PRELIMINARY OVERALL AREA DEVELOPMENT PLAN APPLICATION (POADP)

Date Submitted: 1/23/97 Name of POADP: Fiesta Northwest Crossing

Re: Fiesta Northwest Crossing POADP # 441 - B

The City Staff Development Review Committee has reviewed Fiesta Northwest Crossing Subdivision Preliminary Overall Area Development Plan # 441 - B. Please find enclosed a signed copy for your files. Although your plan was accepted, please note the following:

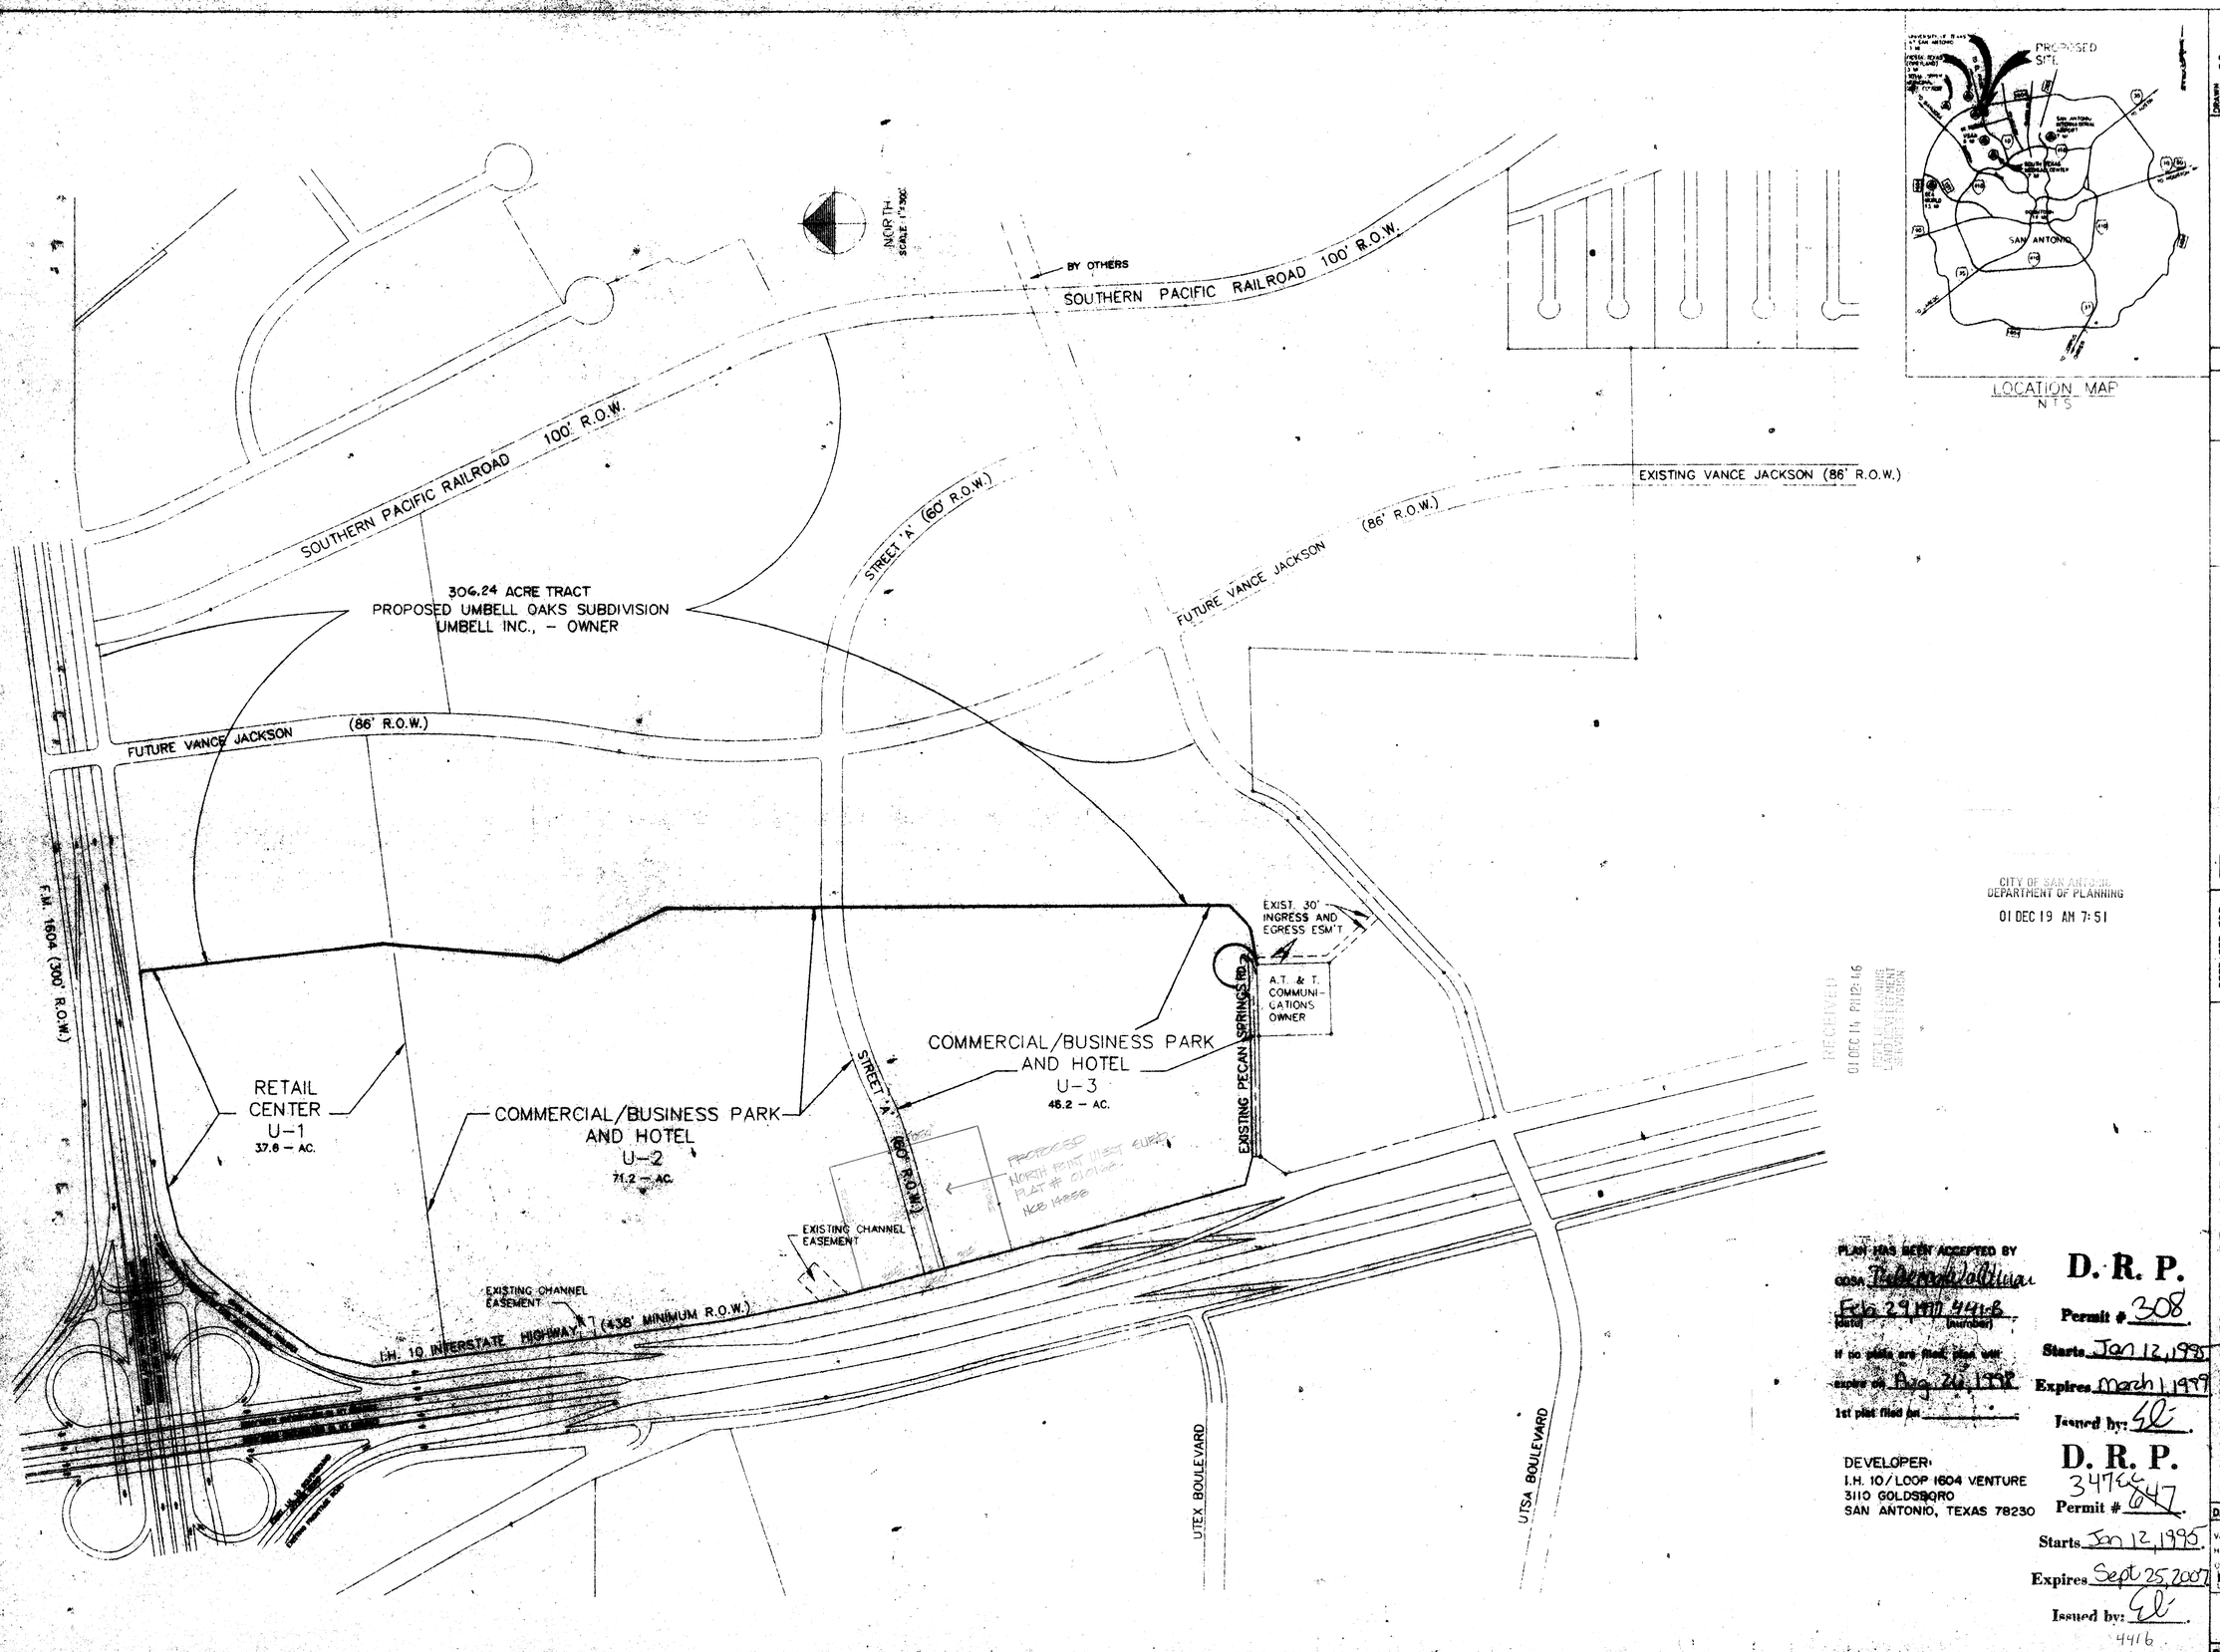
- Based on the topography, a Flood Plain Study and drainage review will probably be required during the platting process.
- This development will probably need to conform to requirements associated with development over the Edwards Aquifer. For additional information about these requirements you can contact SAWS at 704-7305.
- Access issues along State facilities will need to be resolved with the Texas Department of Transportation (TXDOT). For additional information about these requirements you can contact TXDOT at 615-5814.

P.O.A.D.P. Reviewed for:	Comments
Noise Mitigation	For residential development directly adjacent to State ROW, the developer shall be responsible for adequate set-back and/or sound abatement.
R.O.W. Requirements	50' ROW flares will be required at the intersection of the proposed type "A" street with the IH 10 frontage road.
Access Limits/Restrictions	Maximum of 5 access points on IH 10 frontage at "U-3", combined maximum of 9 access points on IH 10 frontage for "U-2 & U-1", maximum of 5 access points on LP 1604 frontage at "U-1". Locations will be as directed by "Regulations For Access Driveways to State Highways".
WPAP Requirements	A complete copy of the approved WPAP will be required at the time of platting.

Comments: Drainage Easement will be require and Address during the platting Process Pecan Springs will meet minimum width requirements

Comments: Level-3 TIA Reqd.
